**ERF 2702, PARK LANE, ONRUSTRIVIER, OVERSTRAND MUNICIPAL AREA:
APPLICATION FOR CONSENT USE AND PERMISSION REQUIRED IN TERMS OF THE
LAND USE SCHEME: URBAN DYNAMICS SOUTH CAPE TOWN AND REGIONAL
PLANNERS ON BEHALF OF OVERSTRAND MUNICIPALITY**

2702 HON (5068/2025)

3 February 2026

Figure 7: 3D view (Lyners Engineers)

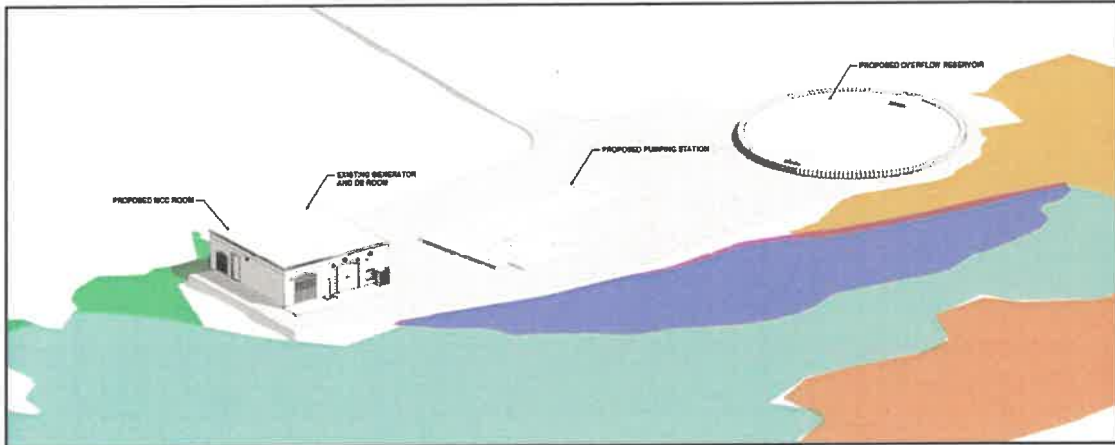
The objector is opposed to the design level of ±600 mm above natural ground level. The objector states that these levels contradict the statements in the planning report that the structures will be underground.

- Both structures will be constructed predominantly underground, as can be clearly seen on the 3D site layout drawing.
- The cover levels of the proposed reservoir and pumping station relate to existing surrounding property levels and their overland drainage, overall overland site drainage, maximizing emergency storage capacities, also taking into account the flood line levels.
- The cover slabs are also not designed to carry heavy traffic loads, which would potentially enter the site. The cover levels are approximately 150mm to 300mm above ground on the northern side and 500mm on the southern side.
- On this basis, it is clear that there are good engineering design reasons and factors informing the levels of the structures, to ensure efficient functioning and operations, as well as safety aspects.

SITE DEVELOPMENT PLAN (PROPOSED)

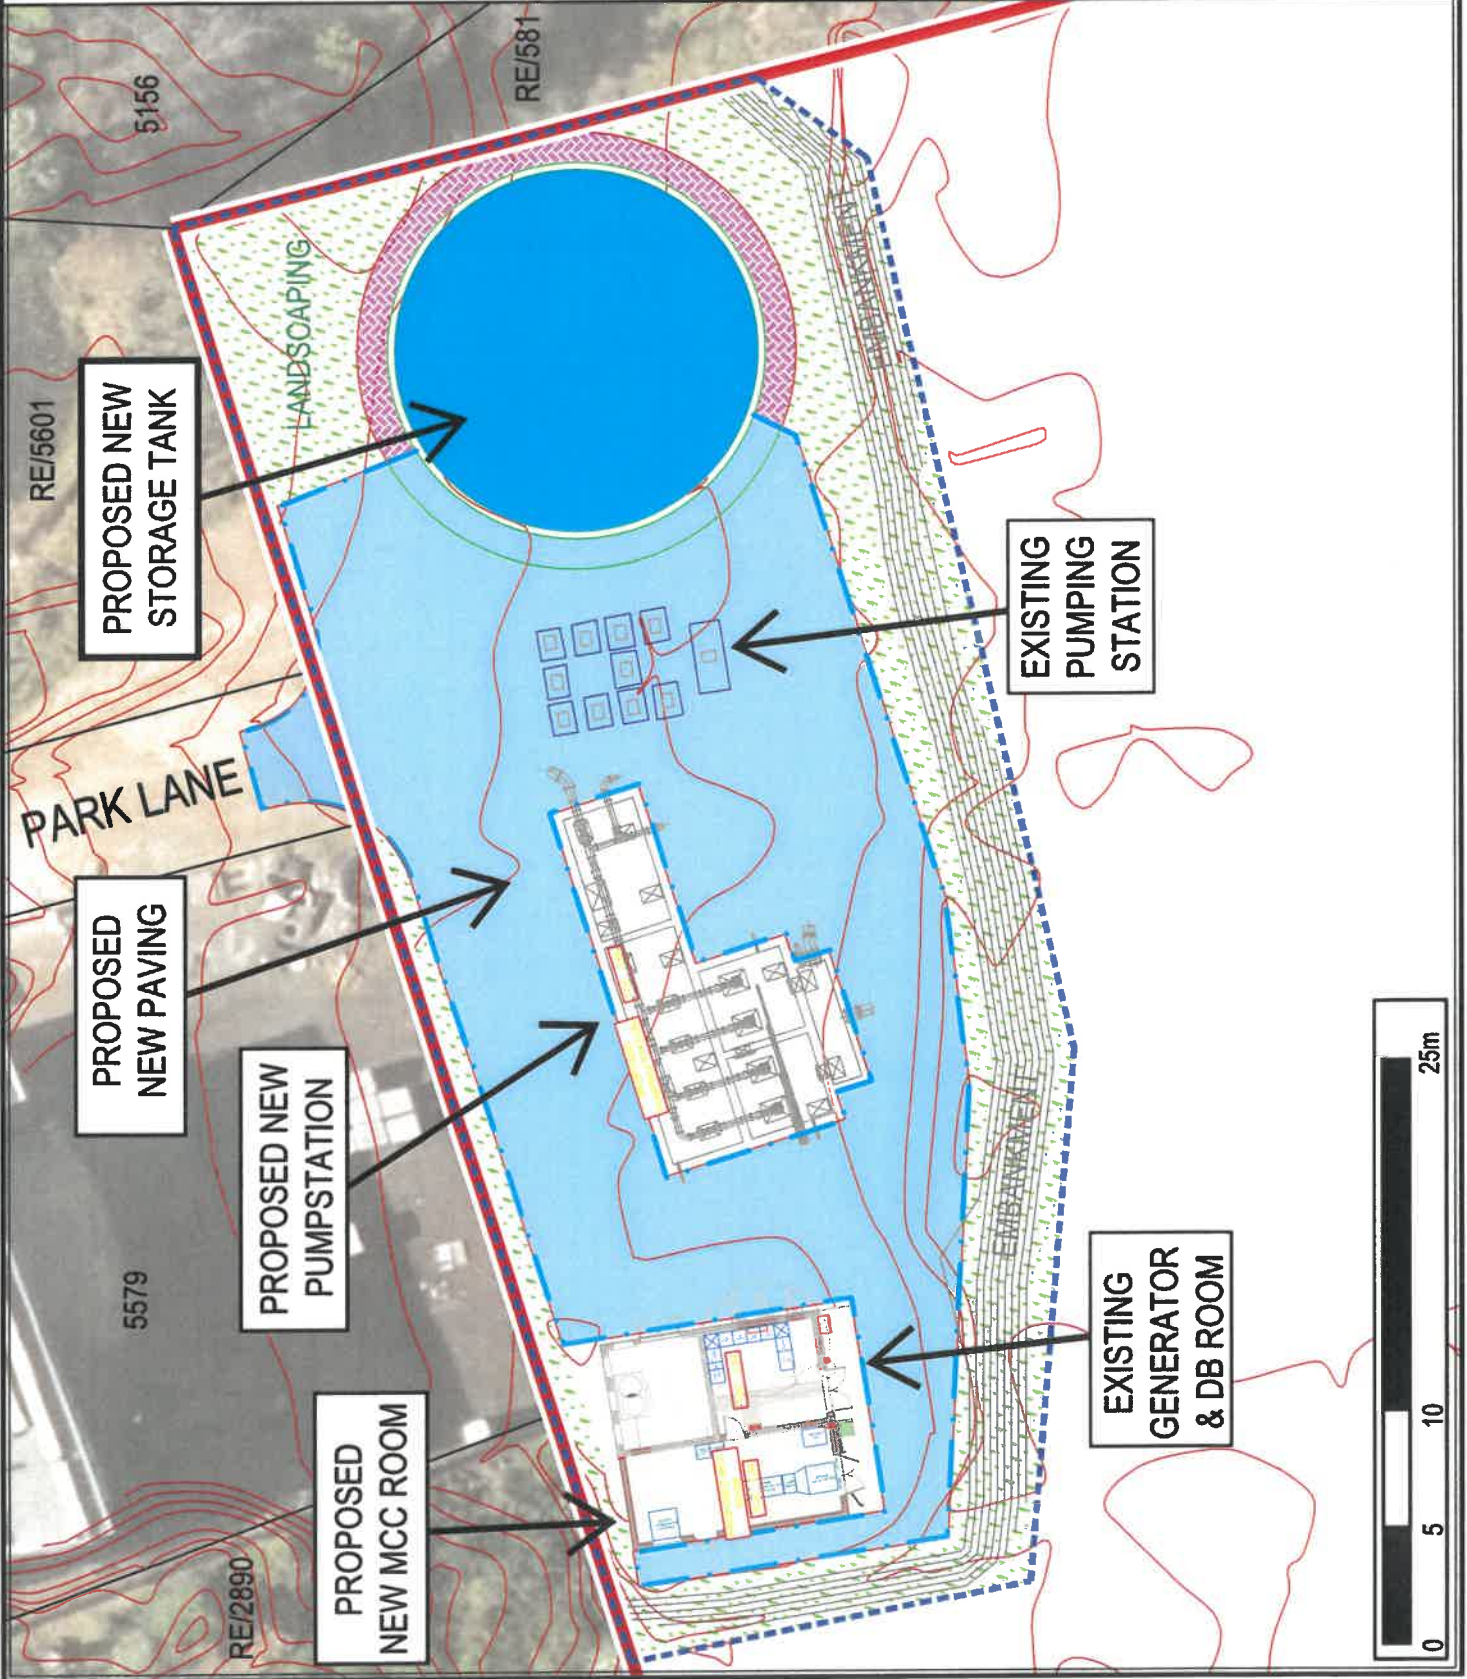
The objector objects against any large, visible, bare reinforced concrete structures including slabs protruding above the 3,08m level. All structures are to be constructed underground & be overlaid by soft landscaping / planting.

- 4.3 The necessity for manhole covers is understood.
 - 4.4 We note that the proposed reservoir straddles erf 2702 & remainder erf 581/0.
 - 4.5 We object to any large, visible, bare reinforced concrete structures including slabs protruding above the 3,08m level. All structures are to be constructed underground & be overlaid by soft landscaping / planting.

- Both structures will be constructed predominantly underground, as can be clearly seen on the 3D site layout drawing.
- The cover levels of the proposed reservoir and pumping station relate to existing surrounding property levels and their overland drainage, overall overland site drainage, maximizing emergency storage capacities, also taking into account the flood line levels.

The applicant's comments are noted, and to landscape the whole slab area would in all probability not work as it cannot carry the additional load. The areas around the storage tank and pumpstation can however be landscaped, and a landscape plan will have to be submitted for approval.
